**DOM-NAF-2-NP, REVISION 0.2-A, REACTOR CORE THERMAL-HYDRAULICS
USING THE VIPRE-D COMPUTER CODE**

**Fleet Report
DOM-NAF-2,
Rev. 0.2-NP-A
(with Appendixes A, B & C)**

**Reactor Core
Thermal-Hydraulics
Using the VIPRE-D
Computer Code**

Fleet Report DOM-NAF-2, Rev. 0.2-A includes:

Figure 1: Locked Rotor Transient Equilibrium Quality Results at Time 3.0 Seconds

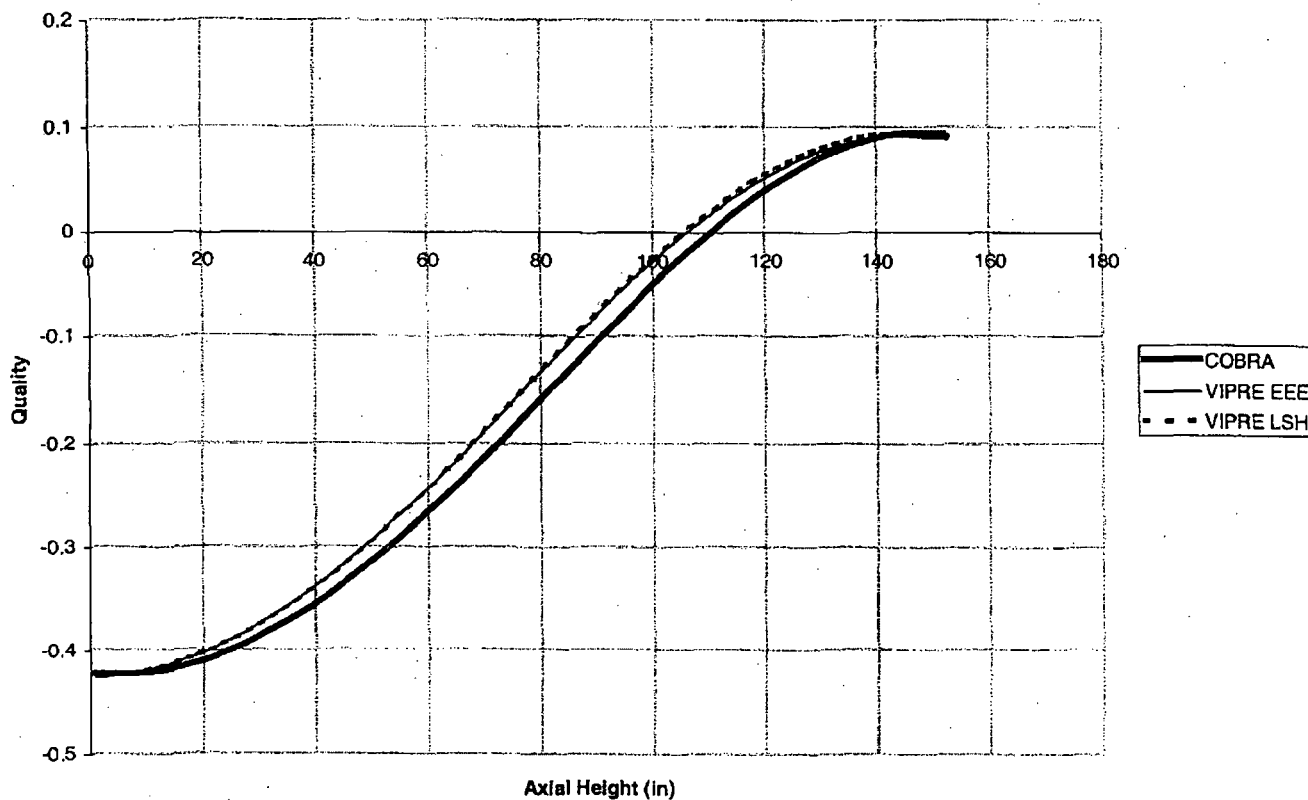
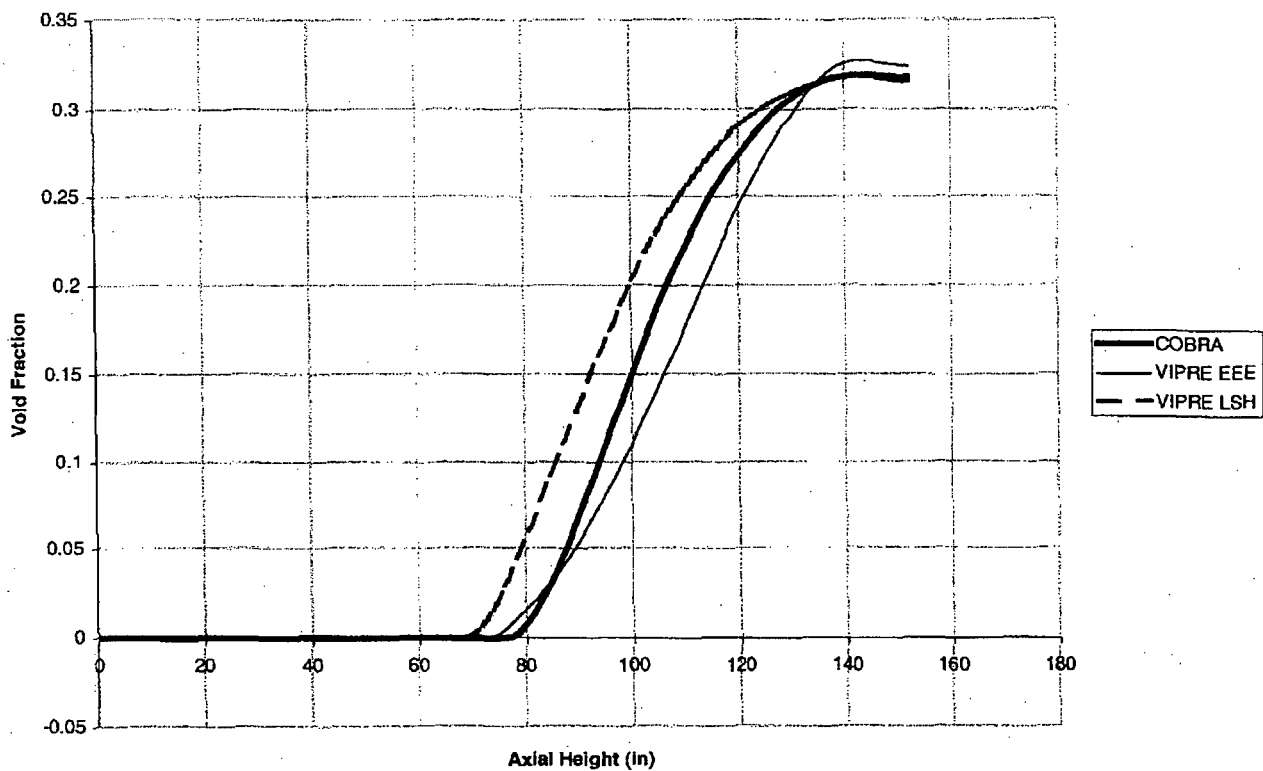
During the May 25, 2005 NRC-Dominion public meeting, Dominion agreed to provide some graphic comparisons to show VIPRE-D's performance for void fraction and quality. Figures 1 and 2 provide a comparison between the VIPRE-D/WRB-1 and the COBRA/WRB-1 codes. In particular, these figures show the void fraction and quality axial distributions in the hot channel at the time of minimum DNBR (3.0 seconds) for a Locked Rotor Transient event at Surry Power Station. Additional description and results associated with this transient were included in Section B.7.3 of Appendix B to DOM-NAF-2. In addition to the VIPRE-D/WRB-1 with the EPRI-EPRI-EPRI set of models, Figures 1

Figures 1 and 2 show that the different void and two-phase friction models result in comparable void fraction and quality trends for COBRA and VIPRE-D. However, as noted above, DNBR comparisons are the main criterion used to evaluate the performance of VIPRE-D against other thermal-hydraulics codes and models. These comparisons demonstrated the acceptability of the EPRI models for bulk void, subcooled void and two-phase friction factor for use in the Dominion VIPRE-D models.

Figure 3: VIPRE-D/BWU-Z Probability Density Function

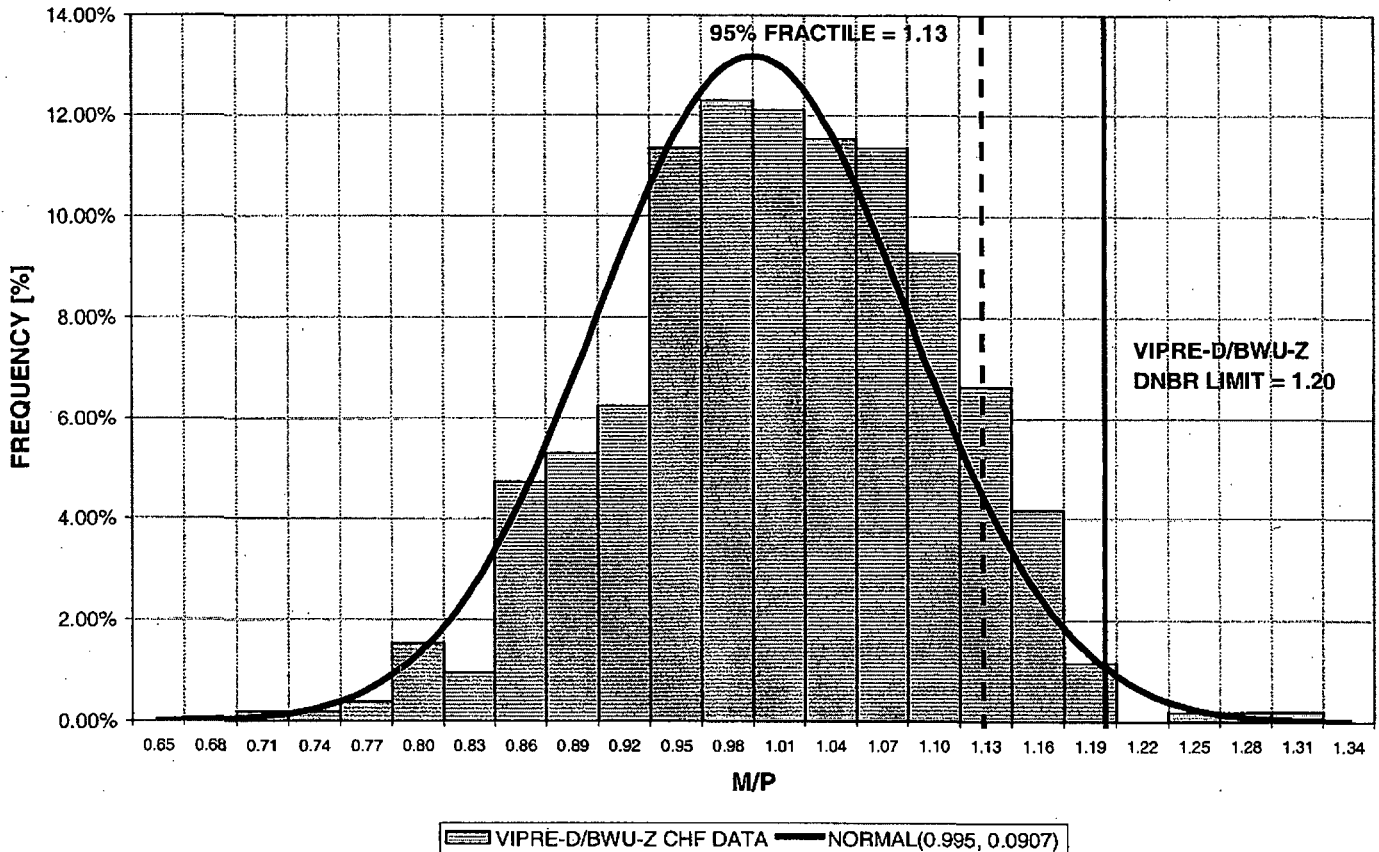
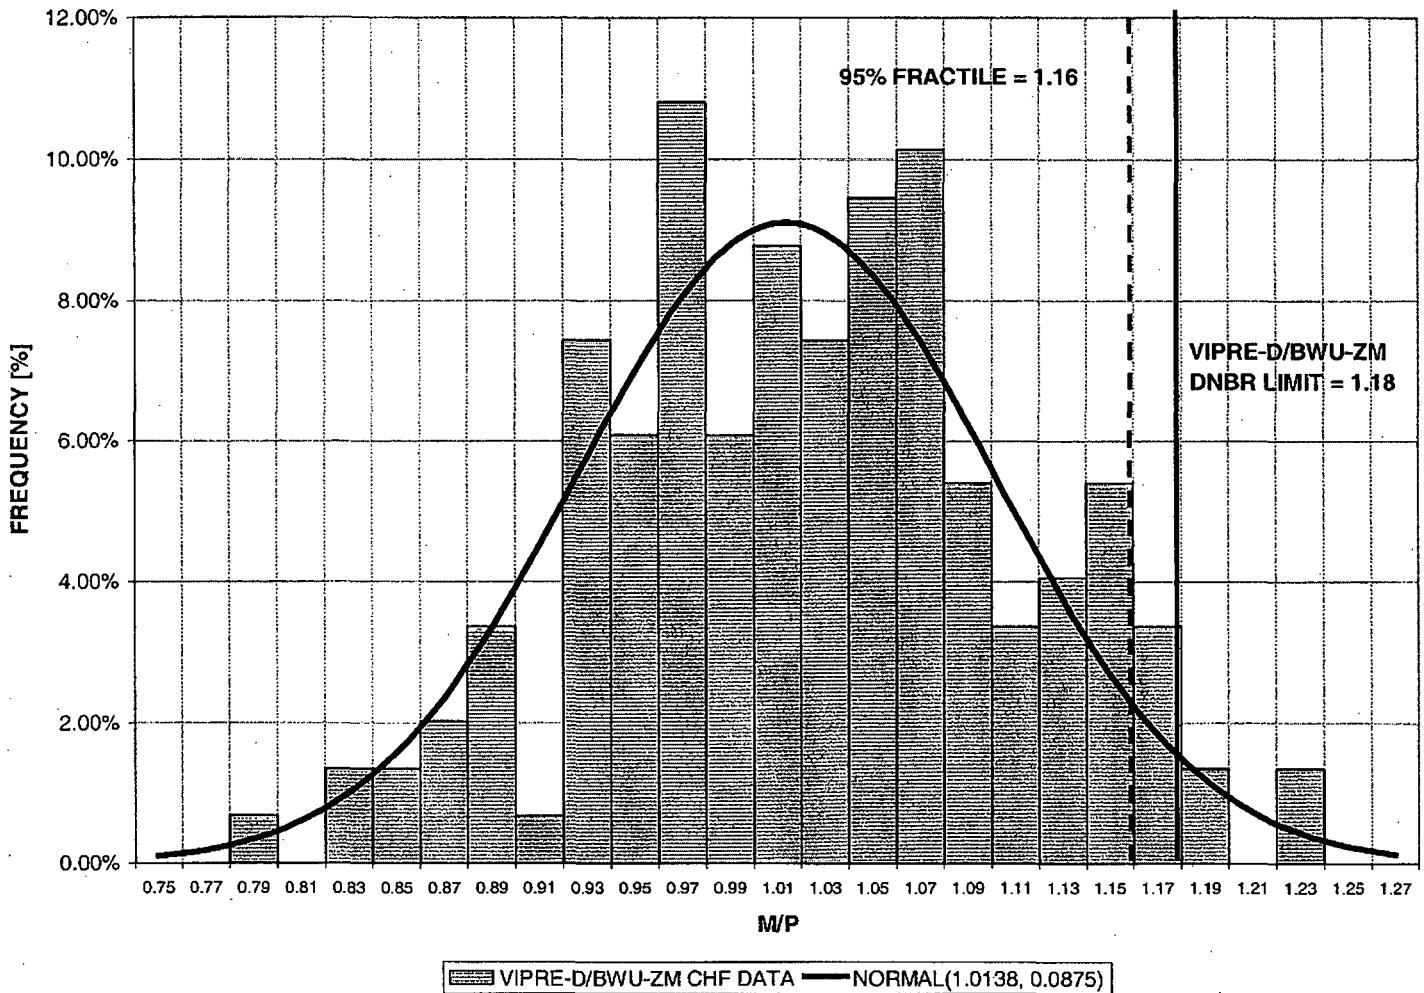
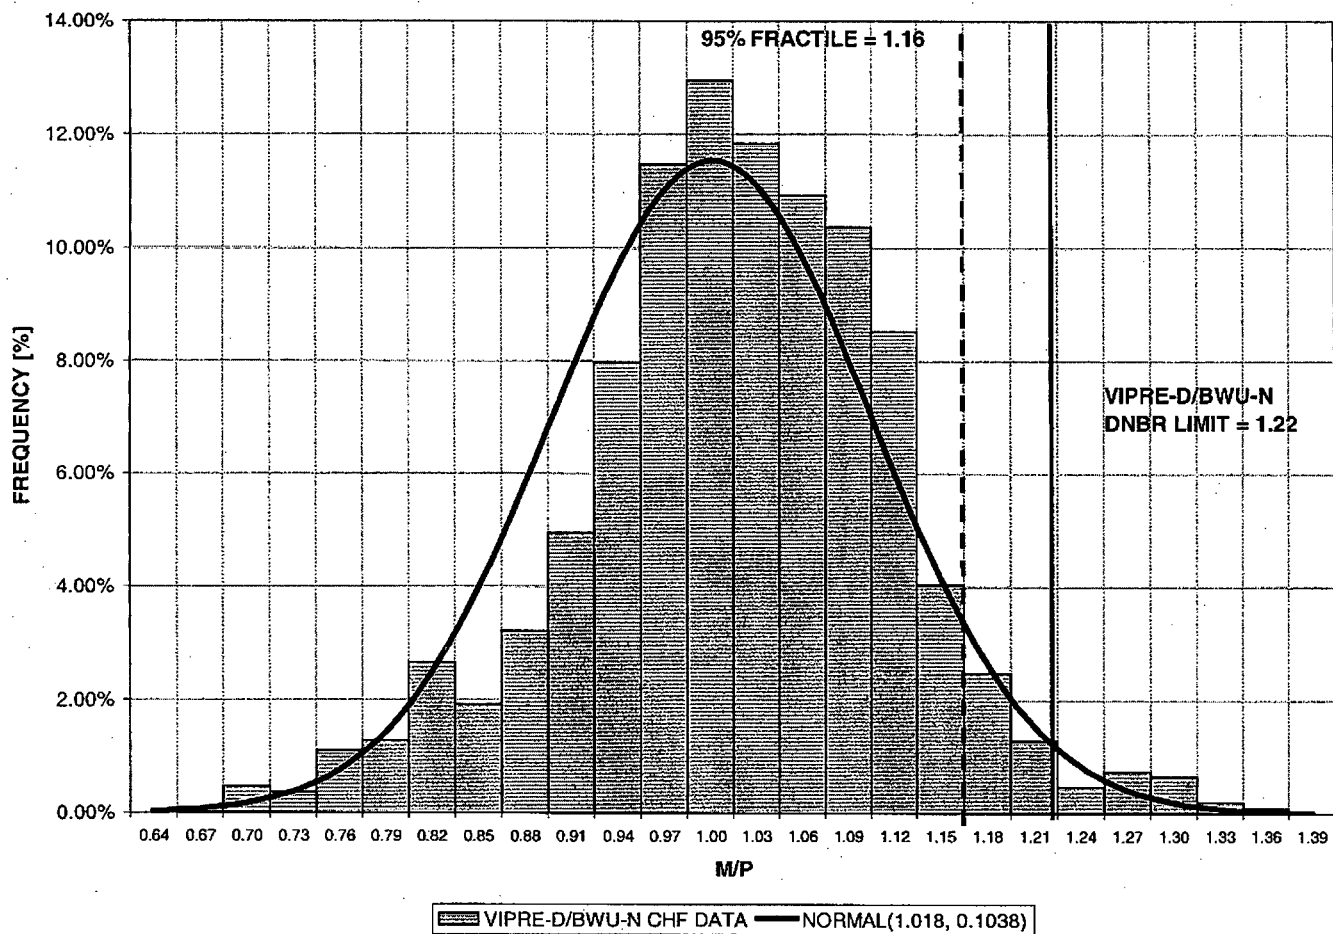
The probability density functions for the BWU-Z, BWU-ZM and BWU-N correlations are shown in Figures 3, 4 and 5.

The 528 datapoints of the VIPRE-D/BWU-Z M/P distribution summarized in Section A.4.1 of DOM-NAF-2 Appendix A were used to create the empirical probability density function. These datapoints were distributed among 24 equal bins that covered the entire range of M/P in the VIPRE-D/BWU-Z distribution, and the frequency of data in each bin was determined. The resulting empirical probability density function for the VIPRE-D/BWU-Z M/P distribution was then compared with the probability density function of a normal distribution of mean 0.995 and standard deviation 0.0907, which are the mean and standard deviation calculated for the VIPRE-D/BWU-Z M/P distribution in Section A.4.1 of DOM-NAF-2 Appendix A. Figure 3 also displays the obtained 95% fractile (1.13) for the data and the VIPRE-D/BWU-Z DNBR limit obtained in Section A.4.1 of DOM-NAF-2 Appendix A (1.20).

The 148 datapoints of the VIPRE-D/BWU-ZM M/P distribution summarized in Section A.4.2 of DOM-NAF-2 Appendix A were used to create the empirical probability density function. These datapoints were distributed among 27 equal bins that covered the entire range of M/P in the VIPRE-D/BWU-ZM distribution, and the frequency of data in each bin was determined. The resulting empirical probability density function for the VIPRE-D/BWU-ZM M/P distribution was then compared with the probability density function of a normal distribution of mean 1.0138 and standard deviation 0.0875, which are the mean and standard deviation calculated for the VIPRE-D/BWU-ZM M/P distribution in Section A.4.2 of DOM-NAF-2 Appendix A. Figure 4 also displays the obtained 95% fractile (1.16) for the data and the VIPRE-D/BWU-ZM DNBR limit obtained in Section A.4.2 of DOM-NAF-2 Appendix A (1.18).

The 1090 datapoints of the VIPRE-D/BWU-N M/P distribution summarized in Section A.4.3 of DOM-NAF-2 Appendix A were used to create the empirical probability density function. These datapoints were distributed among 26 equal bins that covered the entire range of M/P in the VIPRE-D/BWU-N distribution, and the frequency of data in each bin was determined. The resulting empirical probability density function for the VIPRE-D/BWU-N M/P distribution was then compared with the probability density function of a normal distribution of mean 1.0018 and standard deviation 0.1038, which are the mean and standard deviation calculated for the VIPRE-D/BWU-N M/P distribution in Section A.4.3 of DOM-NAF-2 Appendix A. Figure 5 also displays the obtained 95% fractile (1.16) for the data and the VIPRE-D/BWU-N DNBR limit obtained in Section A.4.3 of DOM-NAF-2 Appendix A (1.22).

Figure 6: VIPRE-D/WRB-1 Probability Density Function

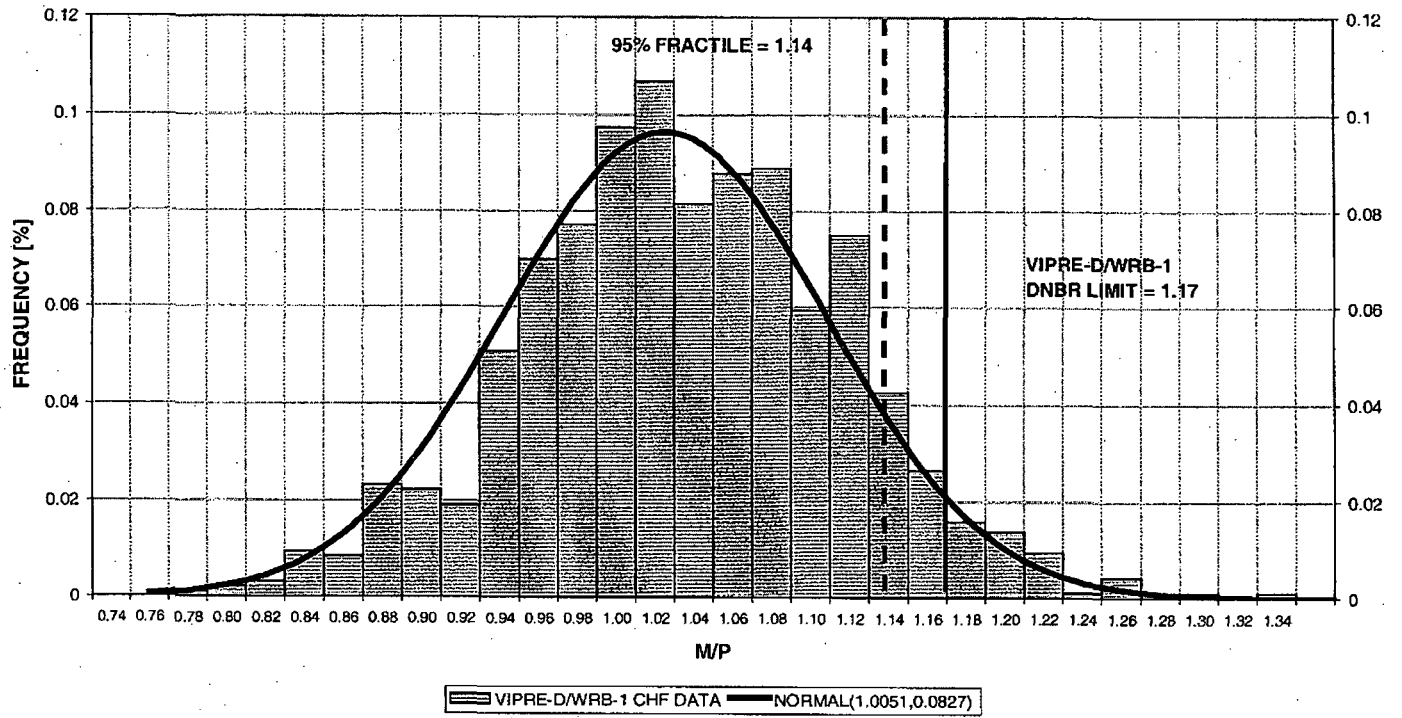
The probability density function for the WRB-1 correlation is shown in Figure 6.

The 945 datapoints of the VIPRE-D/WRB-1 M/P distribution summarized in Section B.6 of DOM-NAF-2 Appendix B were used to create the empirical probability density function. These datapoints were distributed among 31 equal bins that covered the entire range of M/P in the VIPRE-D/WRB-1 distribution, and the frequency of data in each bin was determined. The resulting empirical probability density function for the VIPRE-D/WRB-1 M/P distribution was then compared with the probability density function of a normal distribution of mean 1.0051 and standard deviation 0.0827, which are the mean and standard deviation calculated for the VIPRE-D/WRB-1 M/P distribution in Section B.6 of DOM-NAF-2 Appendix B. Figure 6 also displays the obtained 95% fractile (1.14) for the data and the VIPRE-D/WRB-1 DNBR limit obtained in Section B.6 of DOM-NAF-2 Appendix B (1.17).
